Access Compliance Report
Public Rights-of-Way
(Curb Ramps)

Intersection ID: 3217	Main Street: CARVER_POND_RD	Cross Street: SPRING_PARK_DR	Location: E
ADA ID: 5B623619F65A	Ramp Type: PerpDiag	Initial Pass/Fail: Fail	Overall Compliance: No Severity Score: 47.5

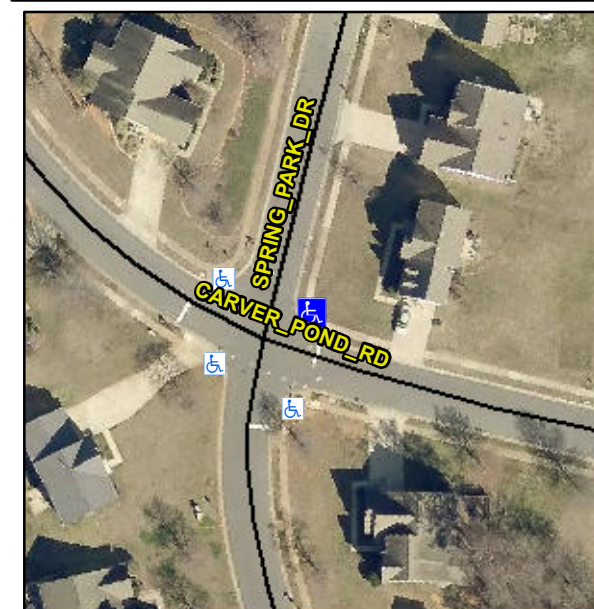
Not Found, R304.5.1, R304.5.3

Compliance	Description	Data	Compliance	Description	Data
N/A	Ramp Length (in)	94.0	Yes	Ramp Slope (%)	5.9
No	Ramp Width (in)	26.0	No	Ramp XSlope (%)	6.6
N/A	Flare Type LT	N/A	N/A	Flare Type RT	N/A
N/A	Flare Slope LT (%)	N/A	N/A	Flare Slope RT (%)	N/A
N/A	Flare Traversable LT?	N/A	N/A	Flare Traversable RT?	N/A
N/A	Landing Length (in)	N/A	N/A	DWS Provided?	N/A
N/A	Landing Width (in)	N/A	N/A	DWS Contrast?	N/A
N/A	Landing Slope (%)	N/A	N/A	DWS Length (in)	N/A
N/A	Landing X Slope (%)	N/A	N/A	DWS Full Width?	N/A
N/A	Landing Curb? (Y/N)	N/A	N/A	DWS Offset (in)	N/A
N/A	Shared Landing?	N/A			
N/A	Gutter Ponding?	N/A	N/A	Gutter Slope (%)	N/A
N/A	Gutter Lip Ht (in)	N/A	N/A	Gutter X Slope (%)	N/A
N/A	Painted X Walk1?	No	N/A	Painted X Walk2?	No
	X Walk 1 Direction	To NW		X Walk 2 Direction	To SW
N/A	X Walk 1 Width (in)	N/A	N/A	X Walk 2 Width (in)	N/A
	X Walk 1 Slope (%)	7.3		X Walk 2 Slope (%)	1.4
	X Walk 1 X Slope (%)	0.7		X Walk 2 X Slope (%)	6.5

Remove & Replace Curb Ramp With Two New Directional Ramps or Equivalent.
